**RE: Reply to Notice in accordance with Article 14(2)(b)(ii) of the Waste Management (Licensing) Regulations for Application 221-1**

On behalf of our client, Dublin City Council, and with reference to your letter dated the 3<sup>rd</sup> of October 2005, in relation to Article 14(2)(b)(ii) request for information pertaining to the Waste Licence Application by Dublin City Council to develop a Civic Amenity Site at a site in Labre Park, Ballyfermot, Dublin 20 (221-1), please find below the information as requested.

**Responses to request for further information on  
Environmental Impact Statement (EIS) for  
proposed Civic Amenity Facility at Labre Park,  
Ballyfermot, Dublin 10**

Client **DUBLIN CITY COUNCIL** DRAWING TITLE **PROPOSED BRIDGE DETAILS**

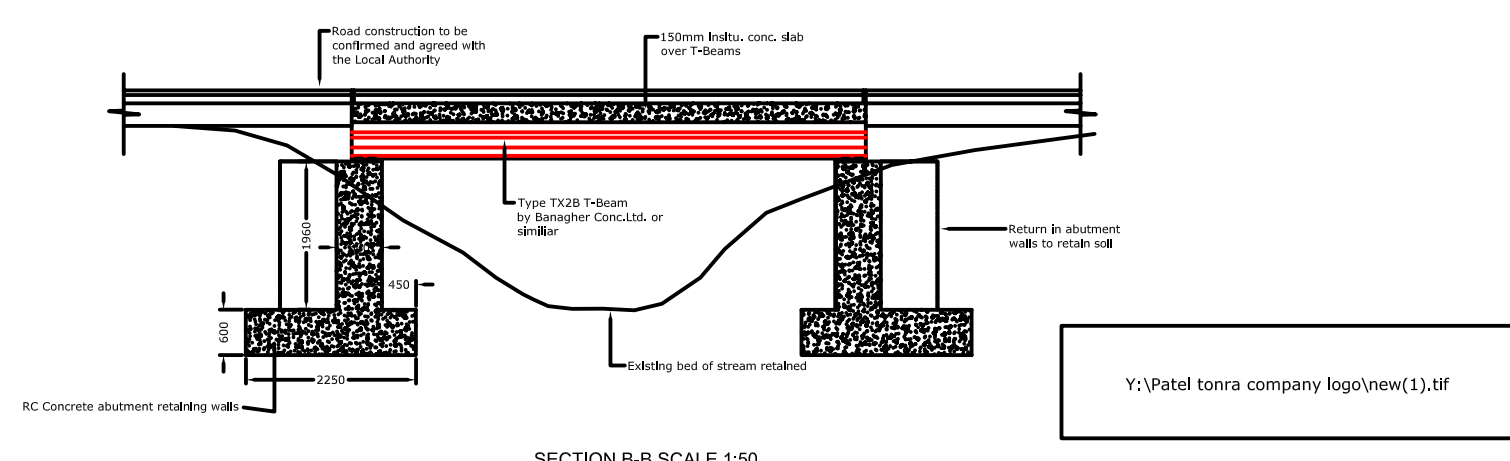
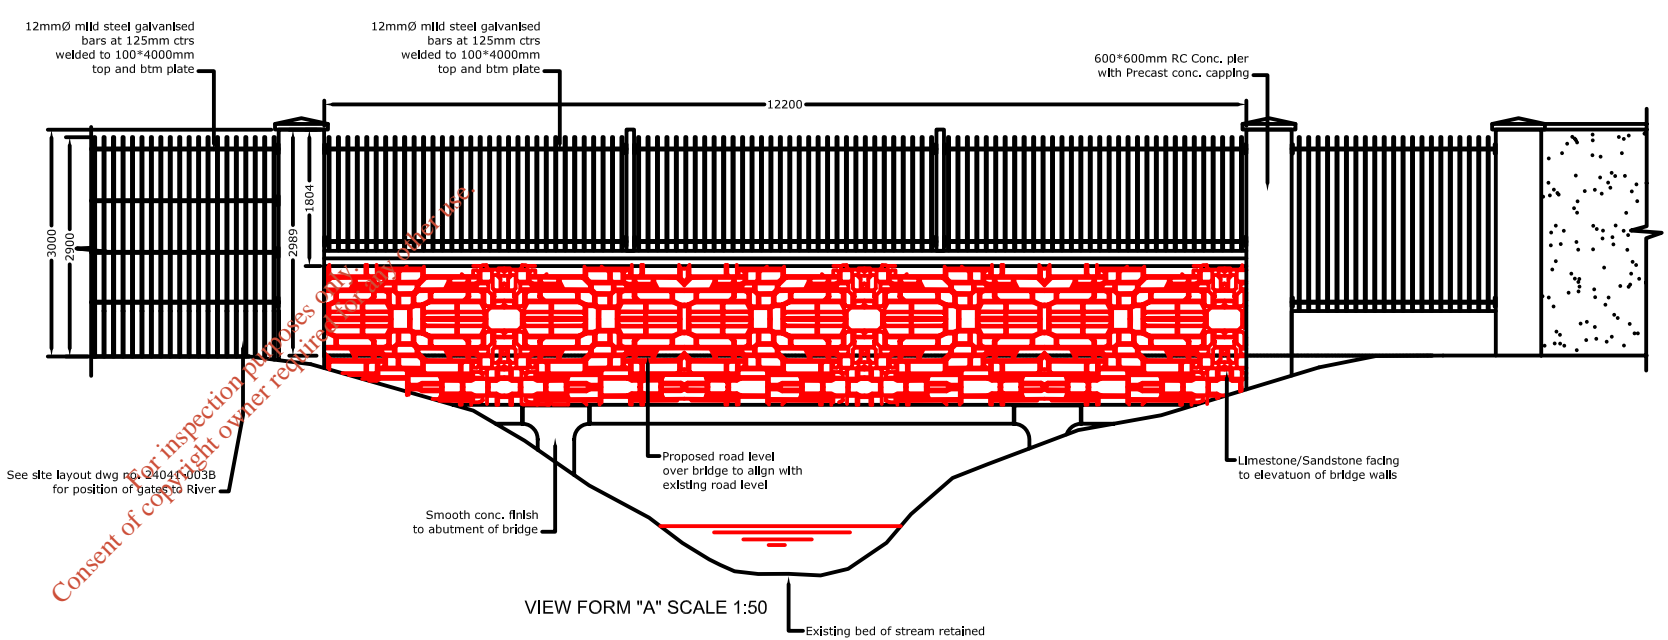
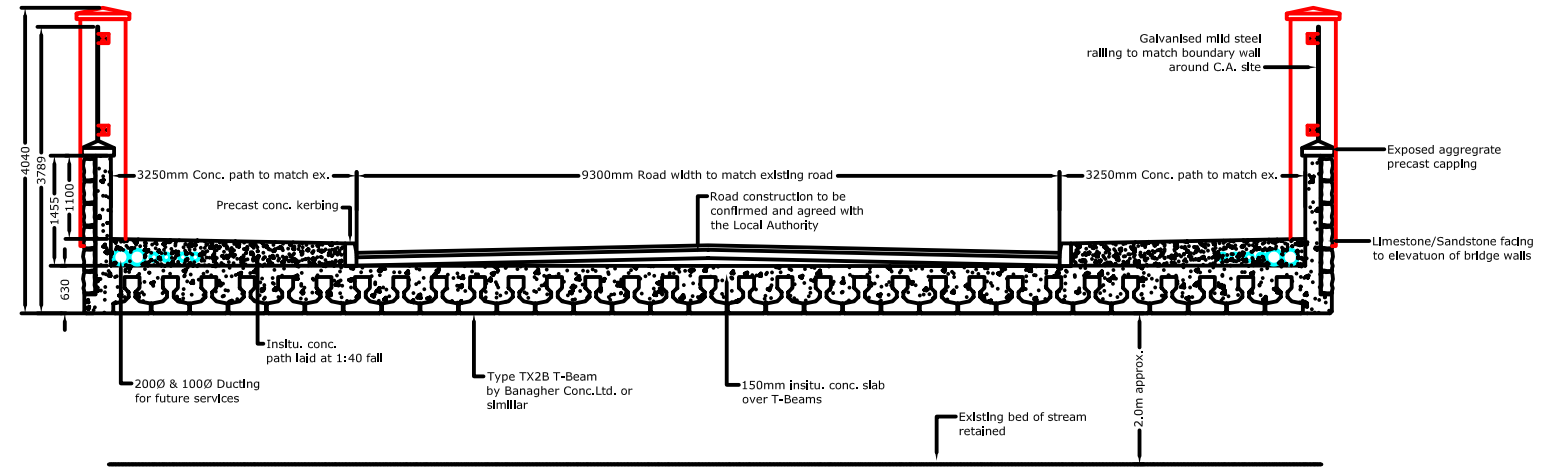
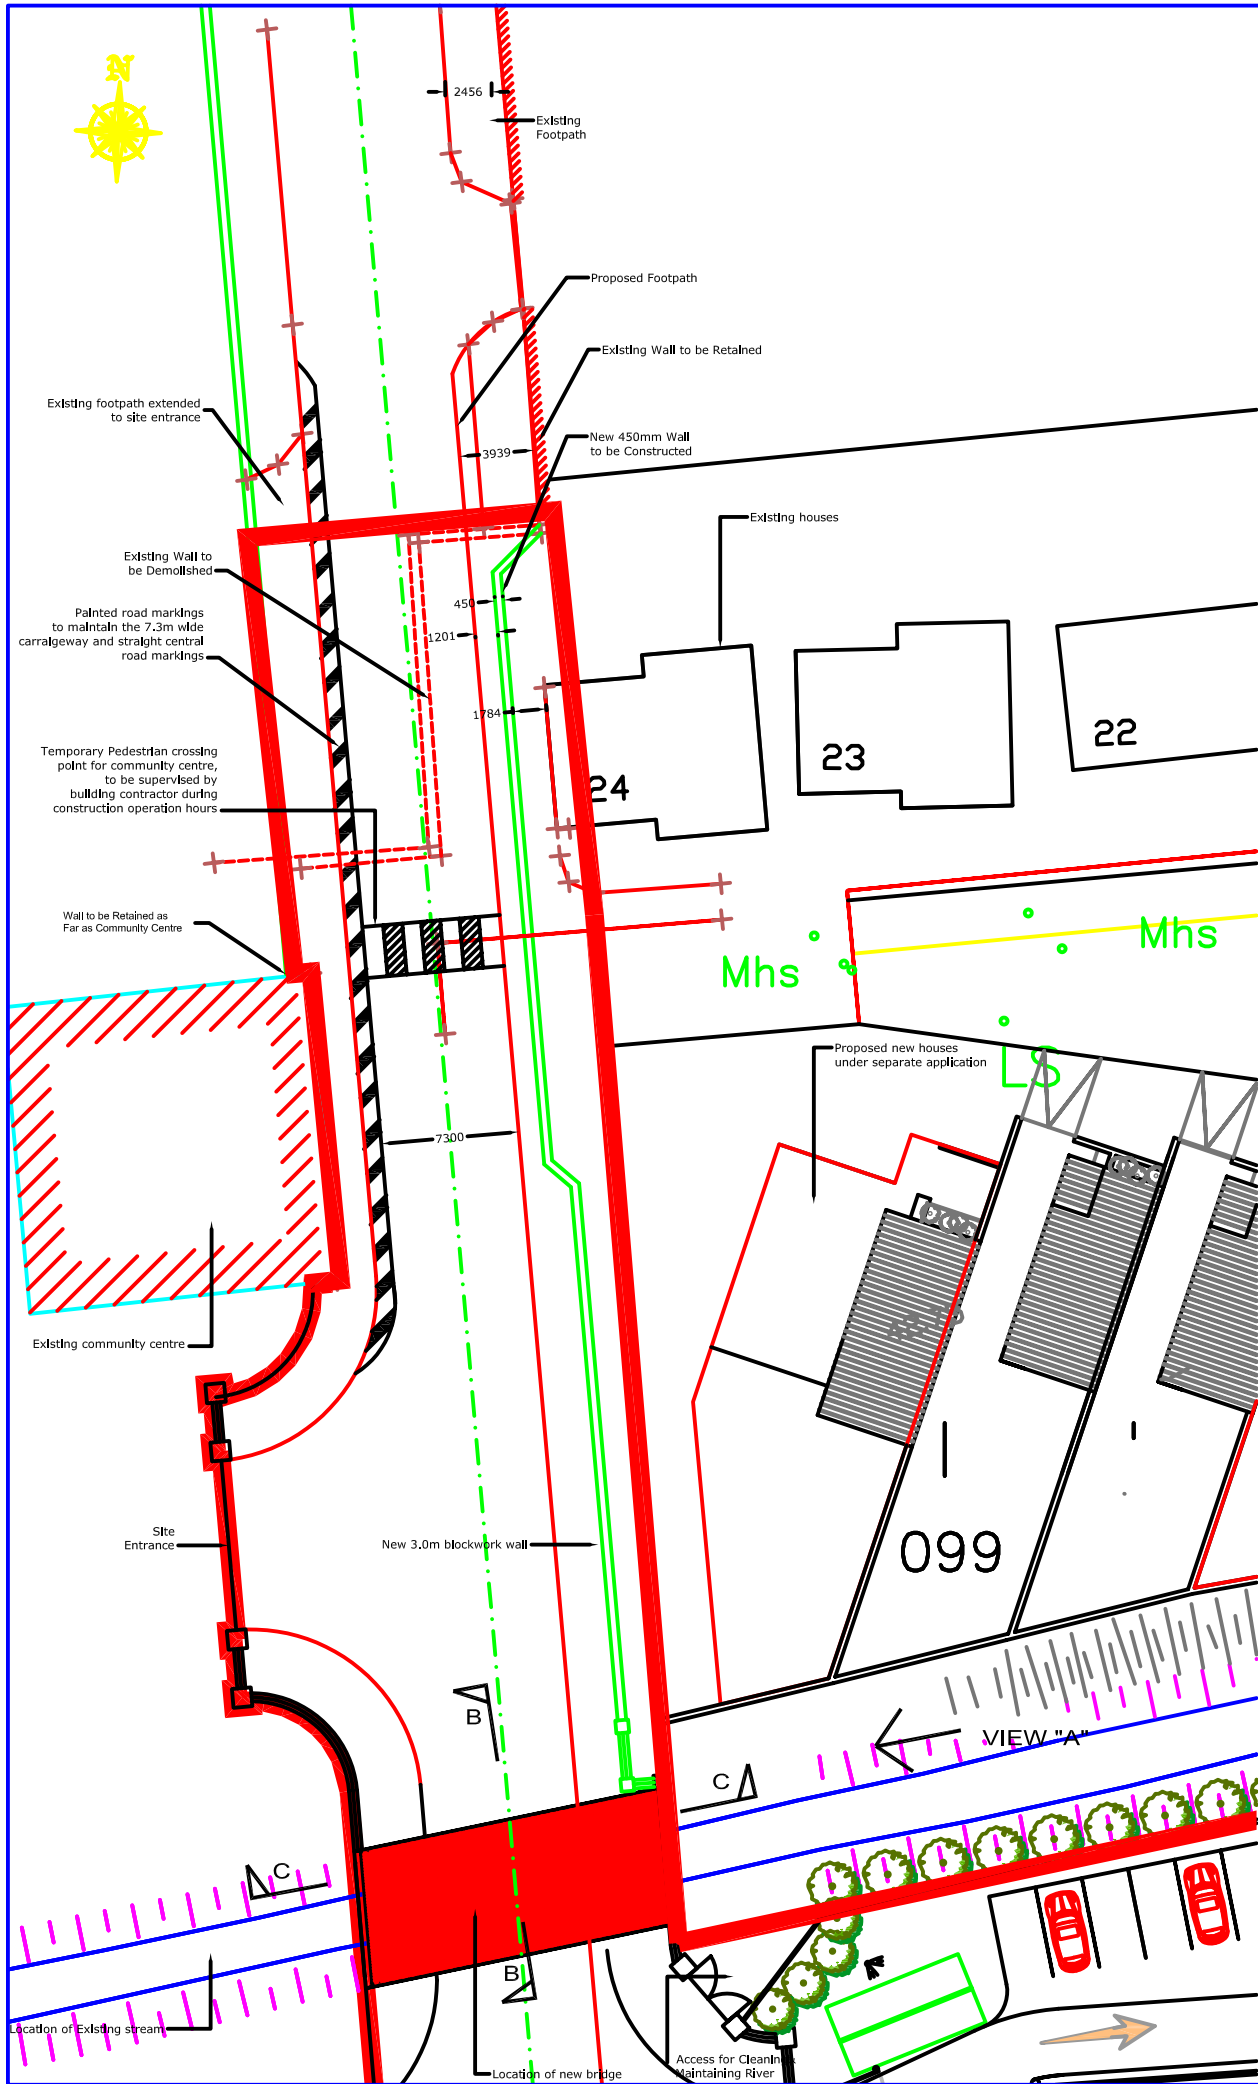
- (d) Drainage details of surface water outfall.
  - (e) Details of entrance with respect to proposed bridge indicated on drawing as being below the entrance.

Drawing 24014-012 (Appendix 5) details the proposed bridge. It is proposed that the bridge will be constructed utilising inverted pre-stressed T- beams in a solid slab and incorporating a stone clad reinforced concrete parapet. The bridge selected allows for the full traffic loading and maintains the vertical and horizontal alignment of the access road. The resulting width under the bridge allows for future maintenance works to the stream without a constriction at the bridge.

Project HOUSING DEVELOPMENT AT LABRE PARK  
Client DUBLIN CITY COUNCIL  
Drawing PROPOSED SITE PLAN

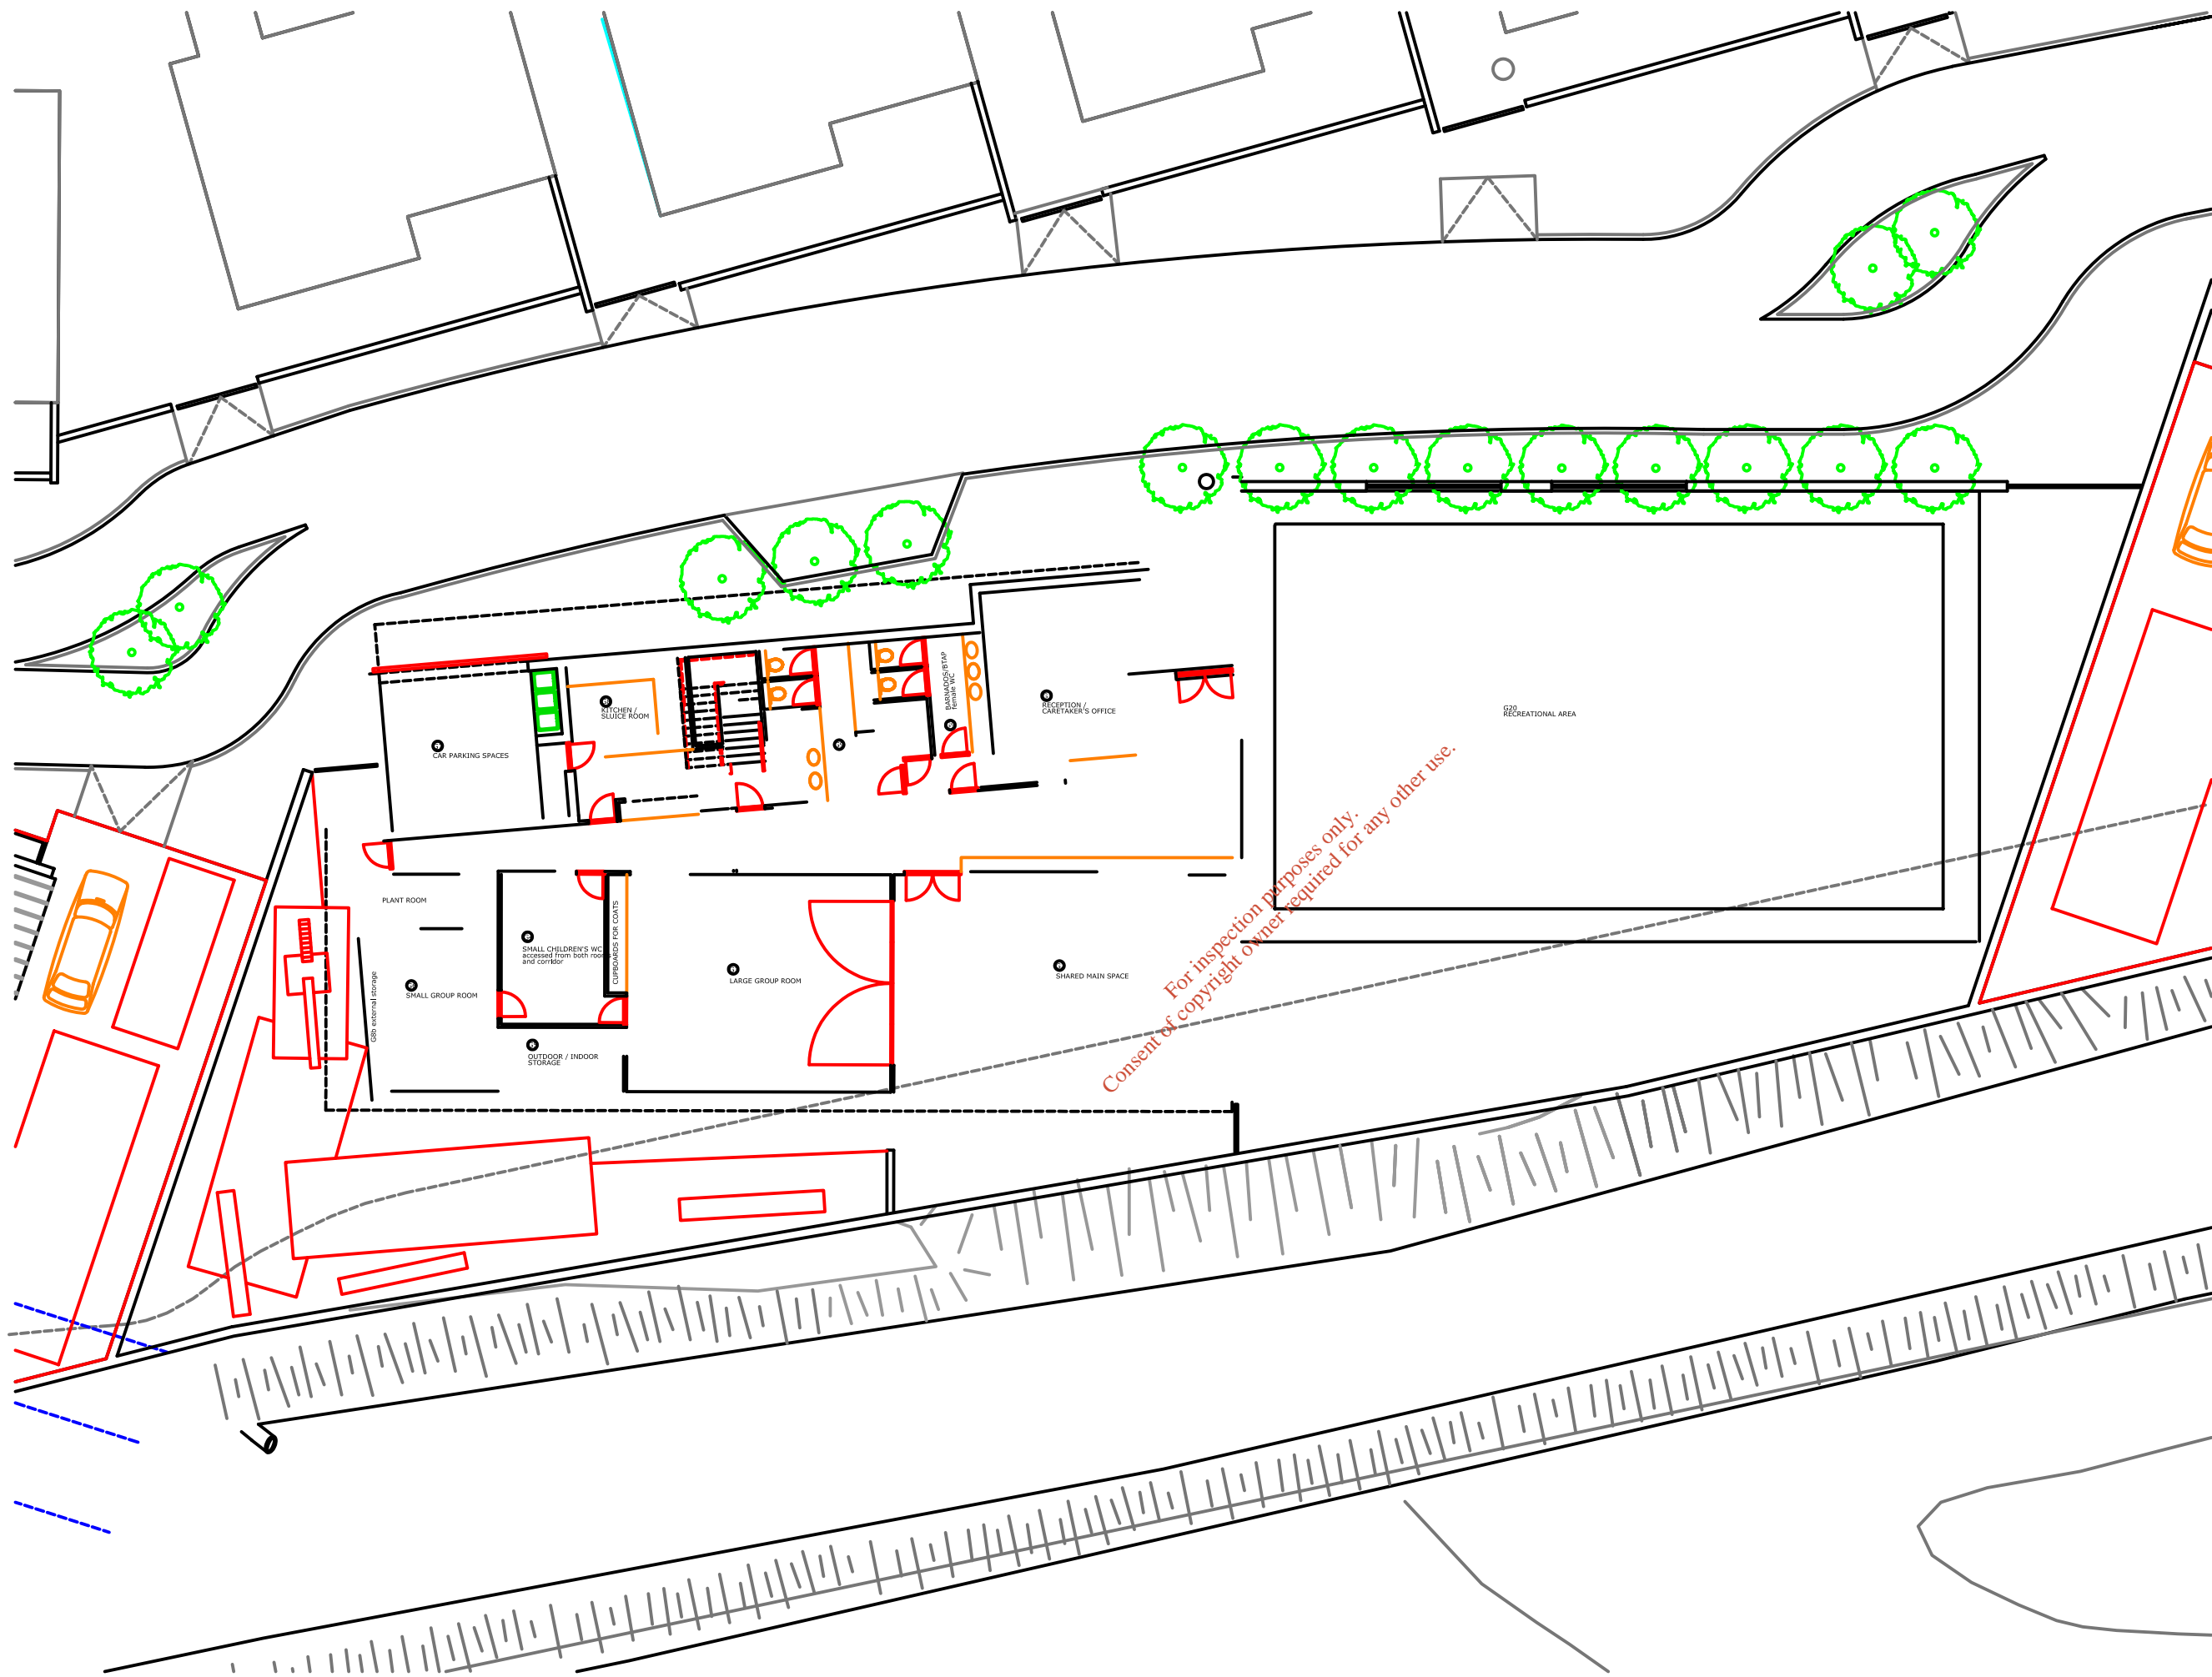
- (f) Details of access road with reference to connection (if any) to Labre Park. Details of impact on building at the west end of Labre Park.
2. In relation to Section 12 of the EIS (Soils and Geology), submit a report on the evaluation of the trial pits, with particular reference to the evaluation of domestic wastes found in the trial pits. Report should contain any recommendations for action/ treatment of such waste.

At present there is a Community Centre located at the western end of Labre Park which is accessible on foot by the residents of Labre Park. It should be noted that there is a separate proposal by Dublin City Council, to construct new housing units and a new Community Centre on the south side of Labre Park. The pre Part VIII process for this development has commenced. A drawing of this development is attached (Appendix 6)

When this development is realised and the new Community Centre has been constructed the existing Community Centre will no longer be used therefore access will no longer be required.
